REMARKS

ANNOTATED MARKED UP DRAWING
 PROPOSED AMENDMENT

REFUSE CONTAINER LID

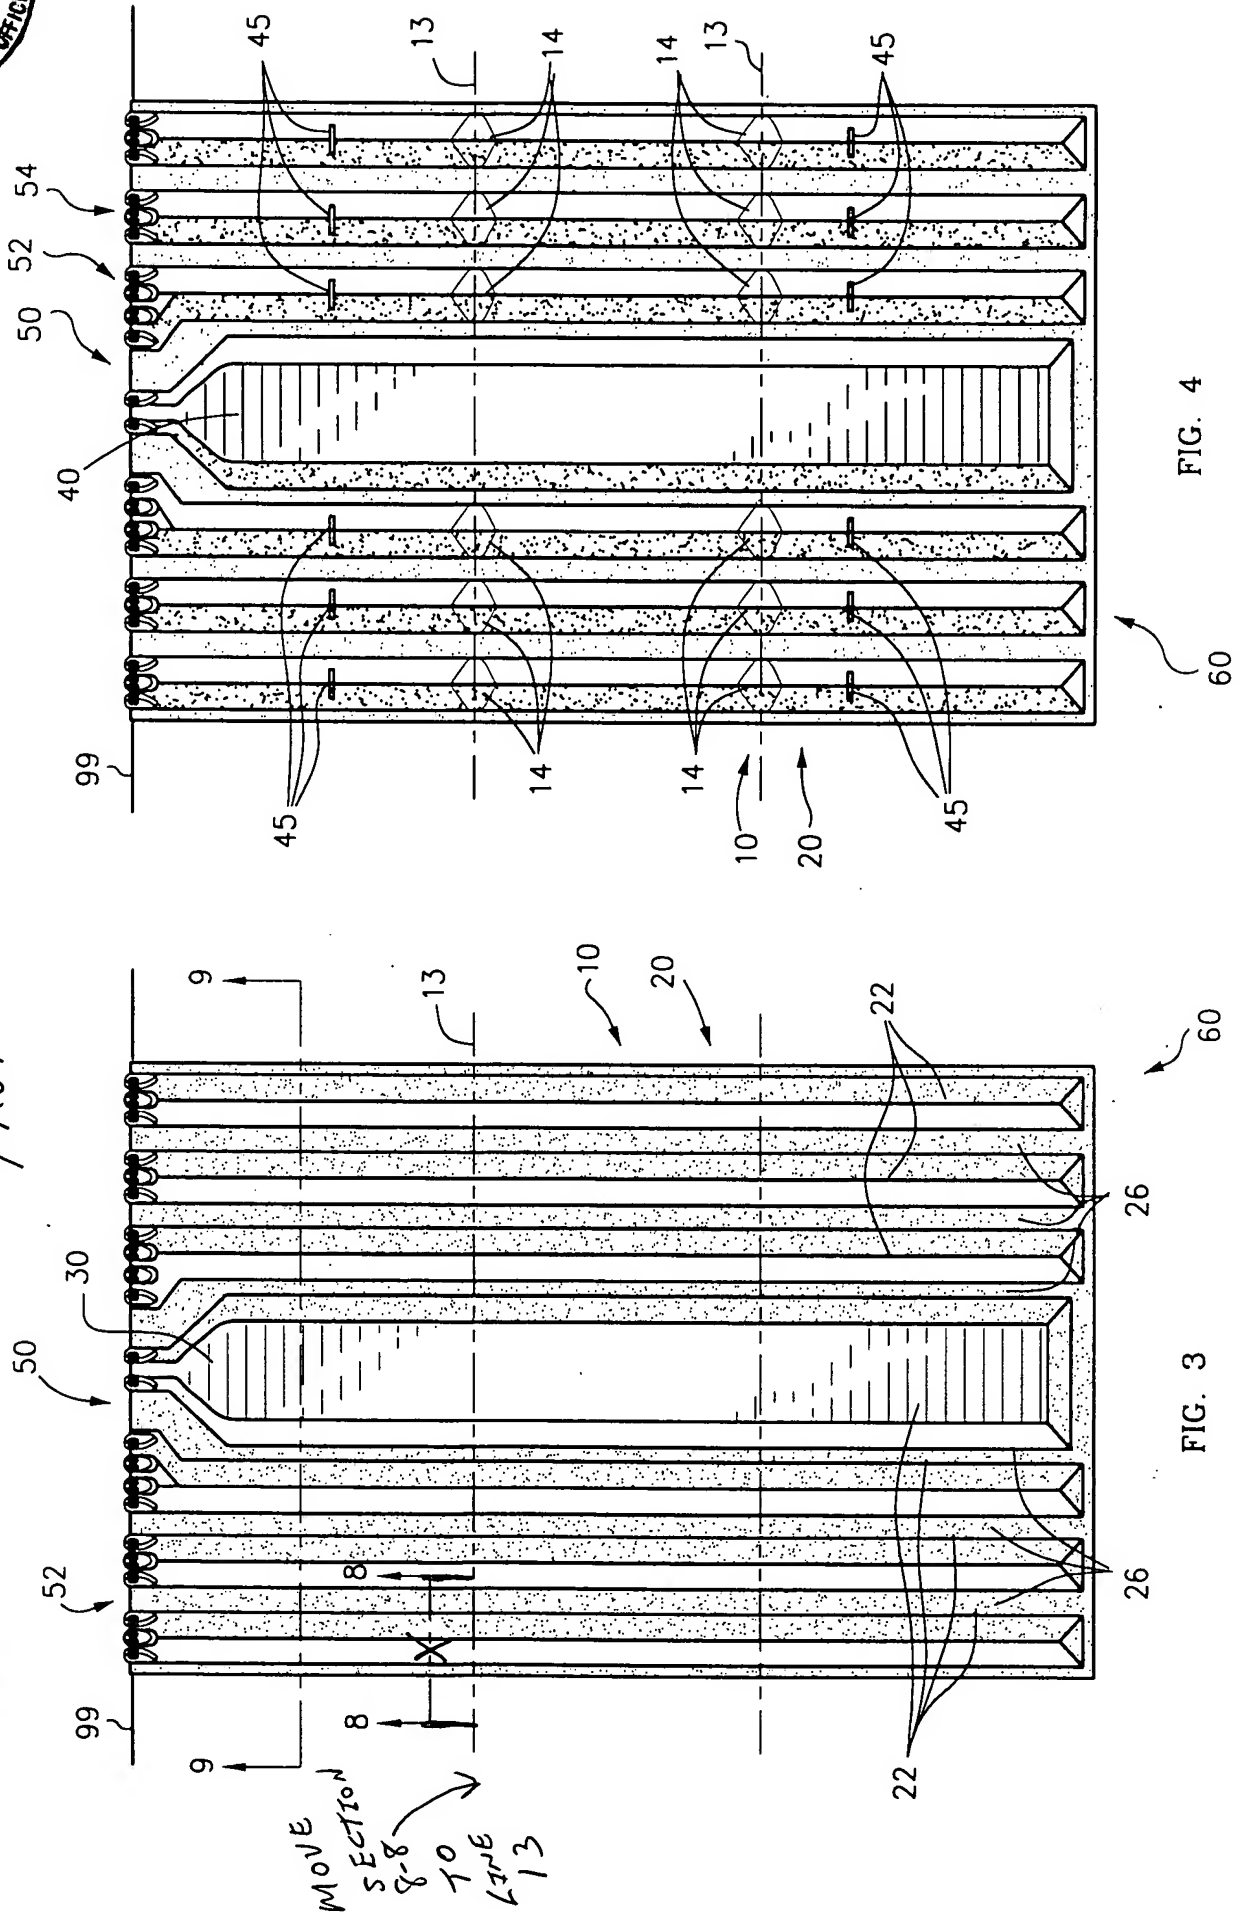
Amend the claims as shown on the attached: First Amendment: Claims Marked Up.
Amend Figure 3 of the drawings as shown on the attached: Amended Drawing, page 3/6.

Figure 3 of the drawing has been amended to move section 8-8 to the bend zone 13 as supported in the Specification discussion of Figures 4 and 10.
